Deferred Submittal Requirements and Application

reference: Permit # 17-186129-000-00-CO Harmer Steel

subject: deferred submittal - Entrance Canopy Glass

HARMER STEEL GLASS CANOPY

HARMER STEEL
CANOPY GLASS AND
BRACKET DETAILS
Portland, Oregon
SK11
INTEGRATE
ARCHITECTURE & PLANNING
www.integratearch.com
1100 NE Oregon Street, Suite 200, Portland, OR 97232

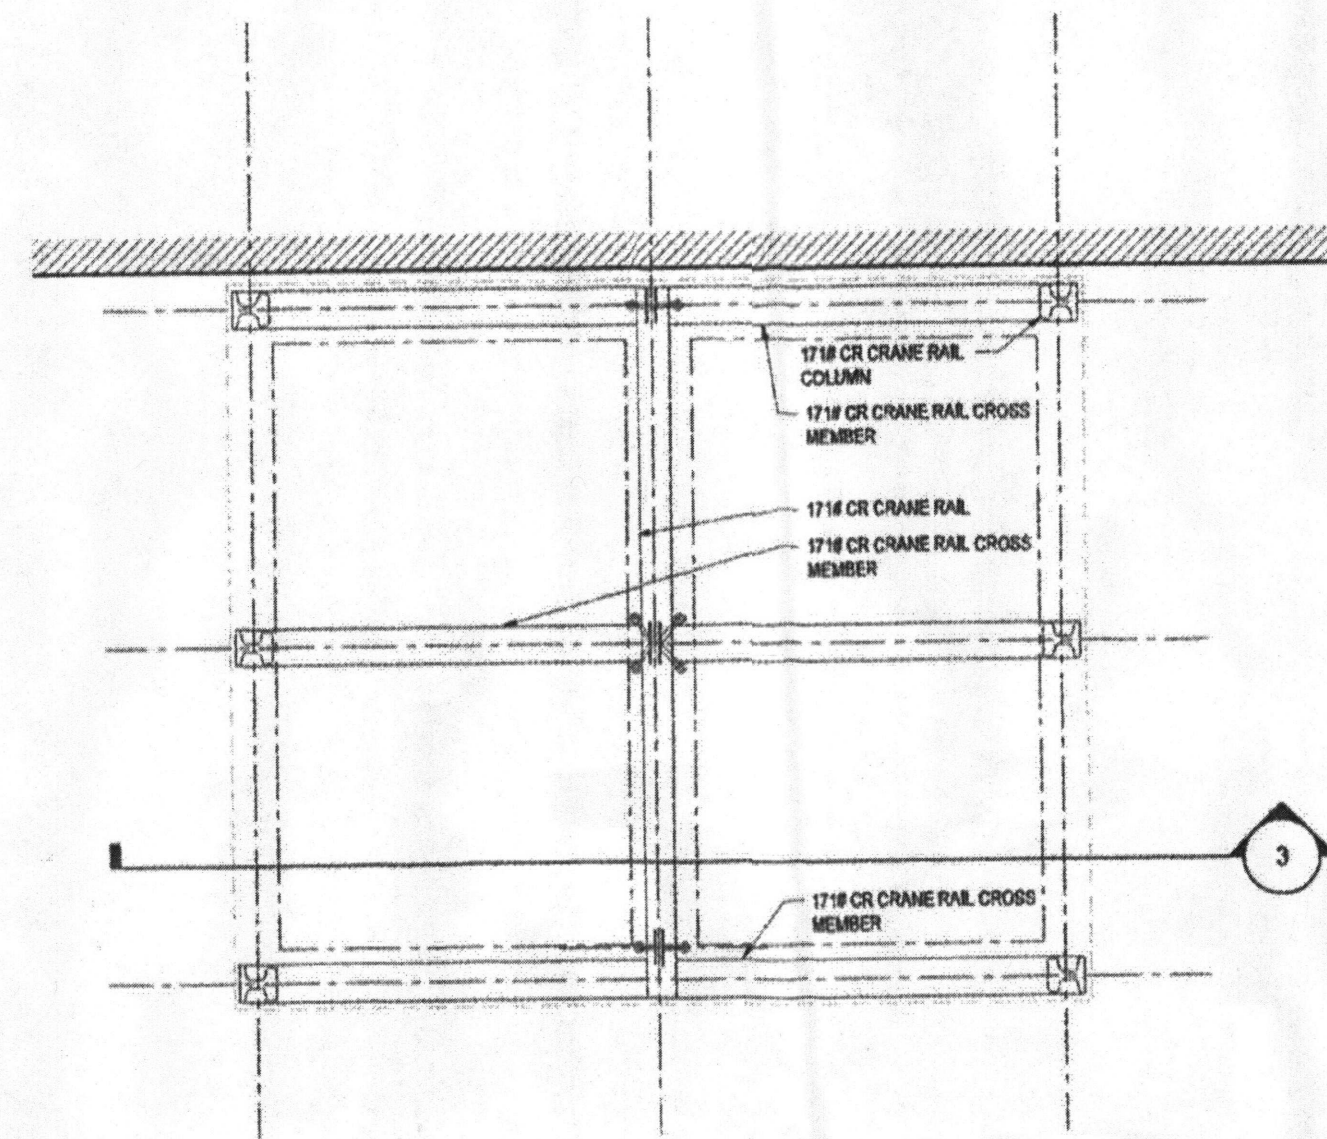
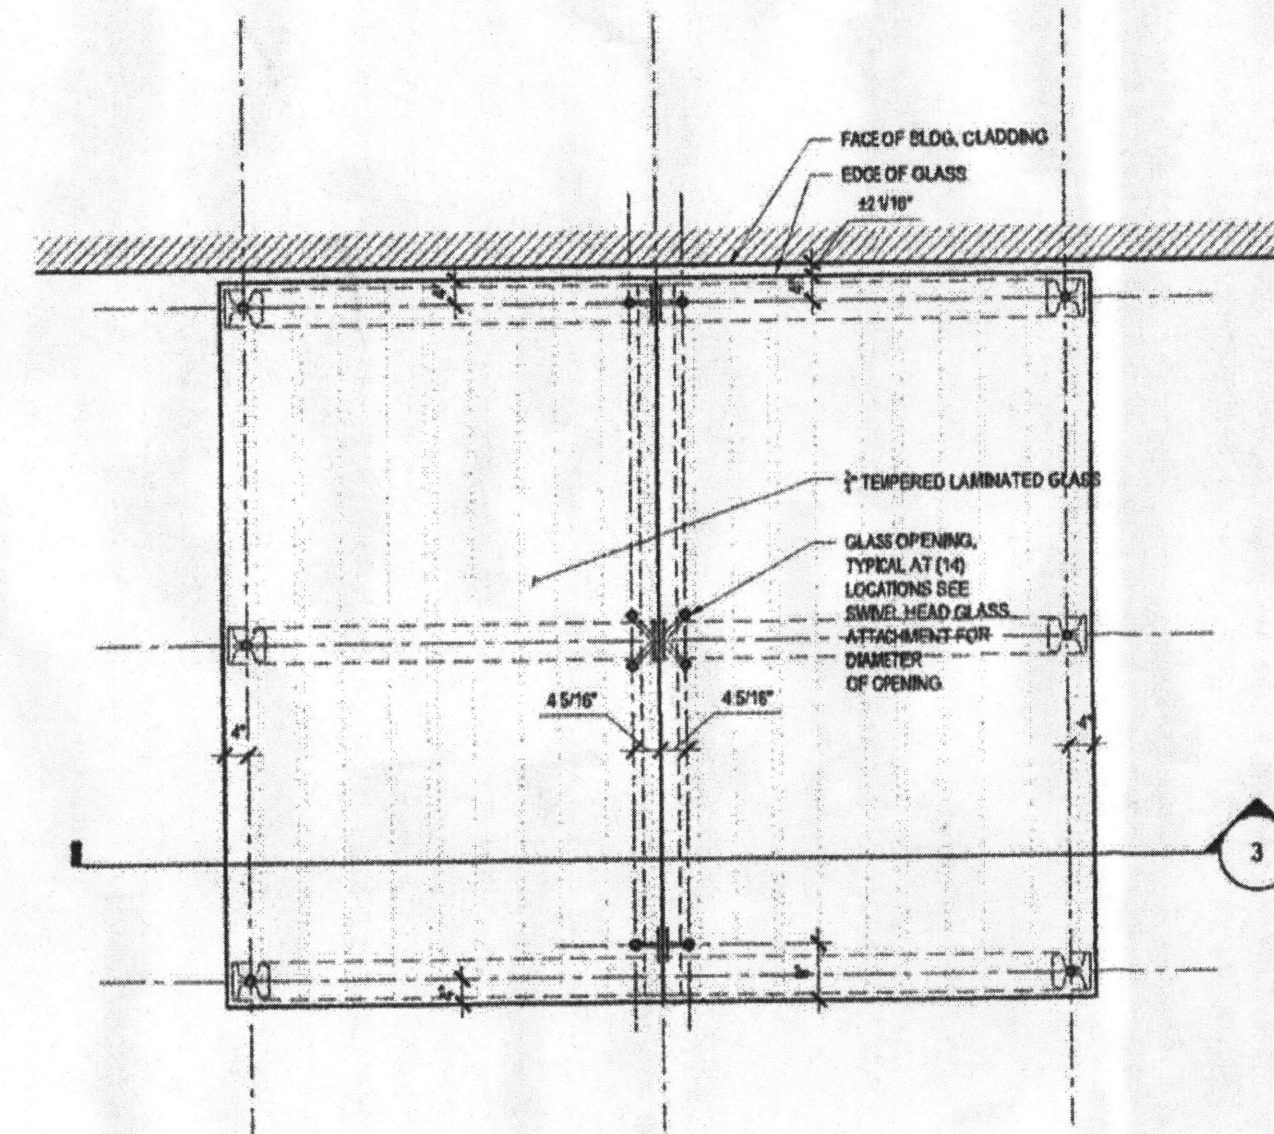
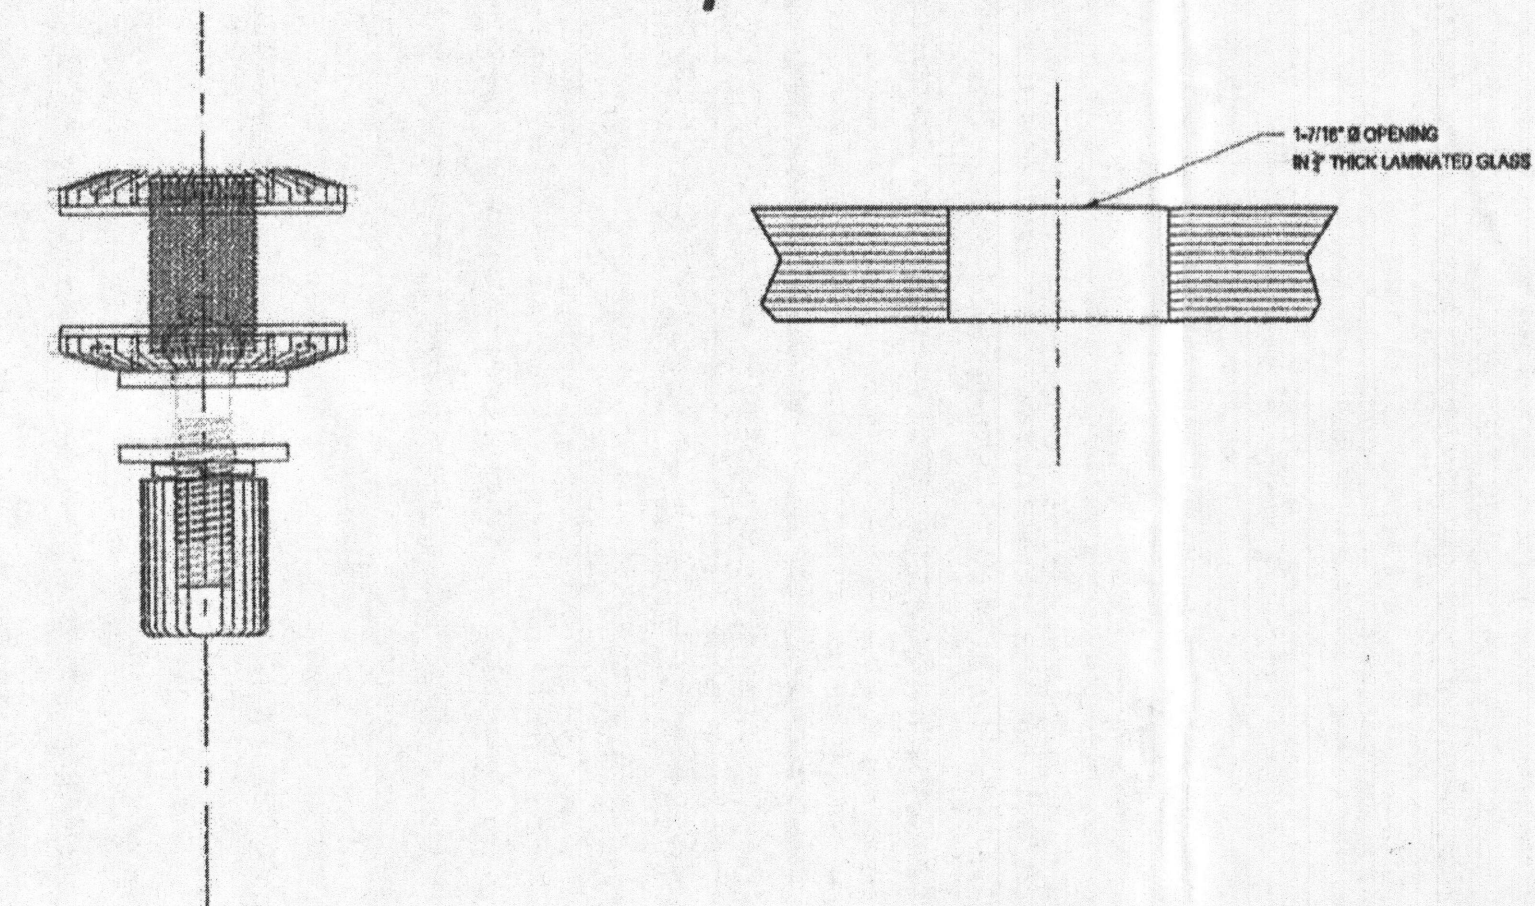
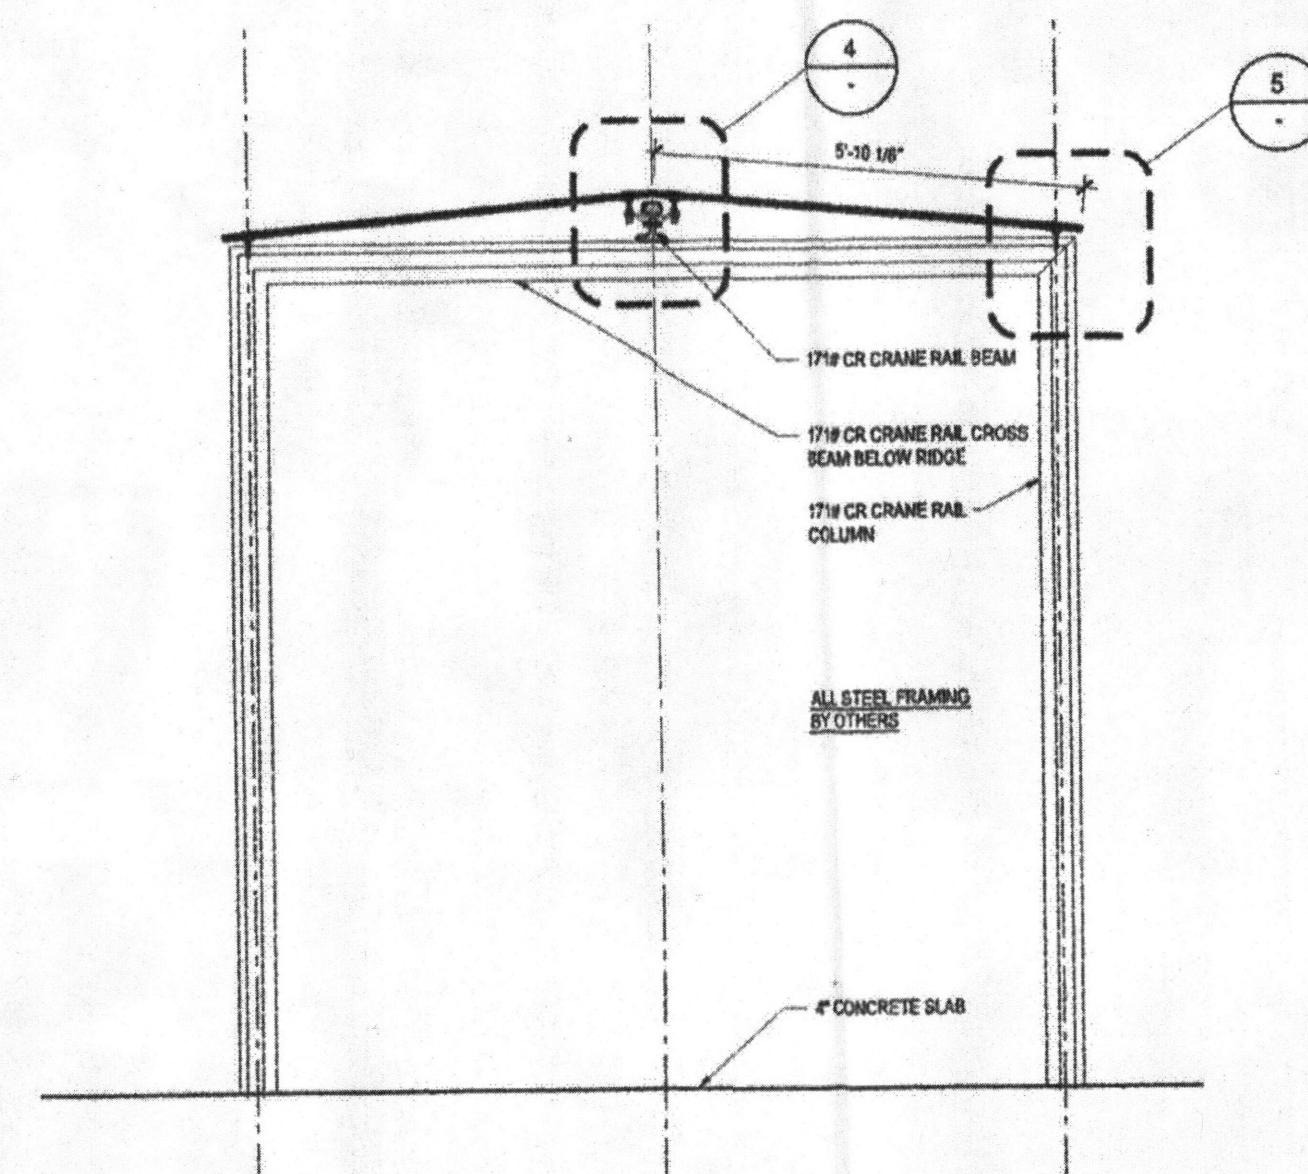
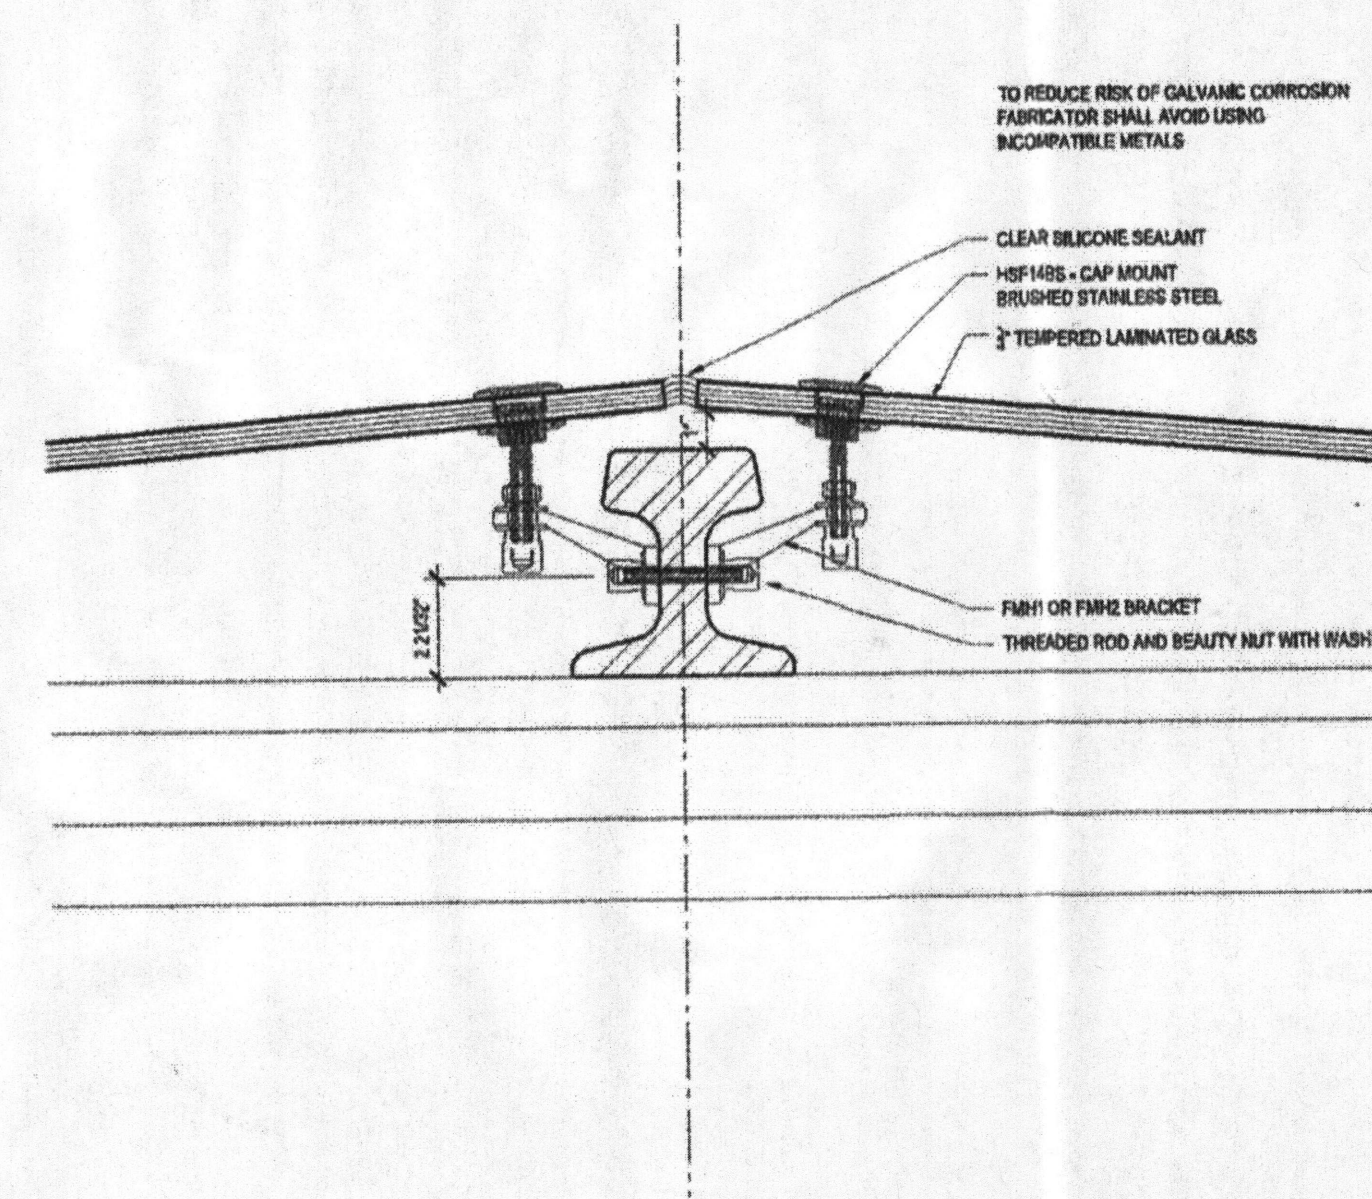
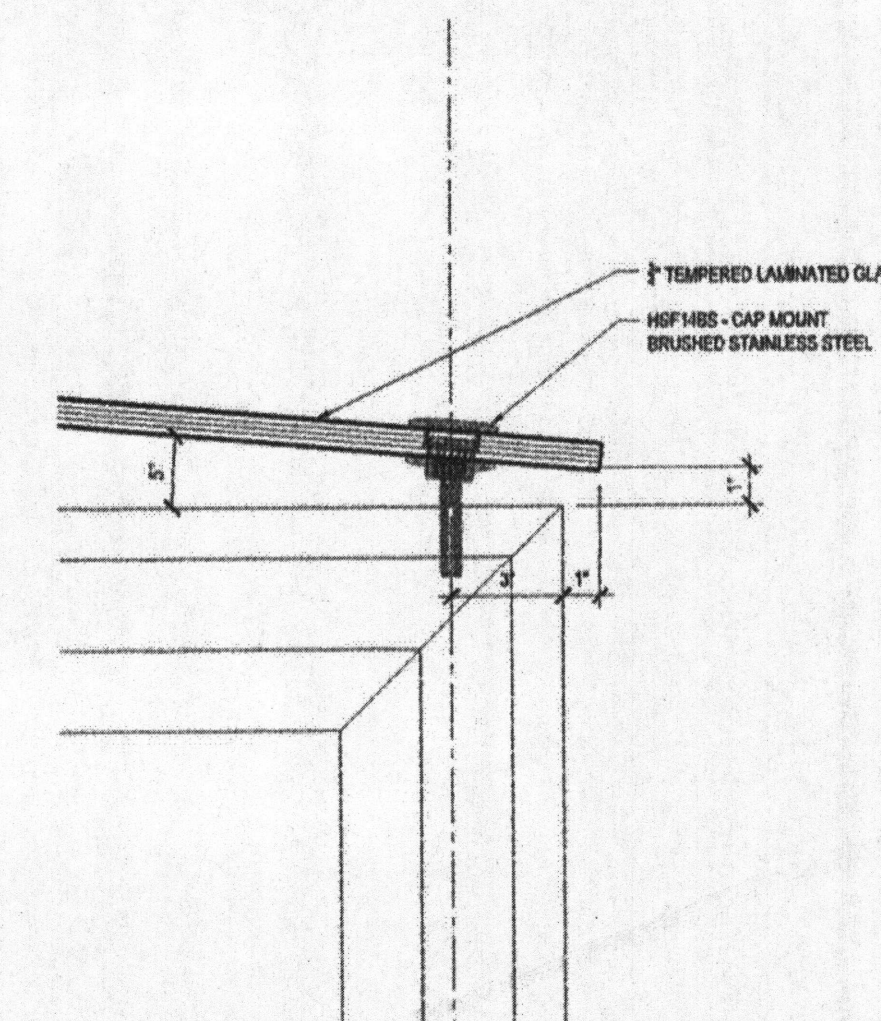
I have also reviewed drawing SK11 prepared by Integrated Architecture and have approved that drawing without exception.

APPROVED WITHOUT
EXCEPTION
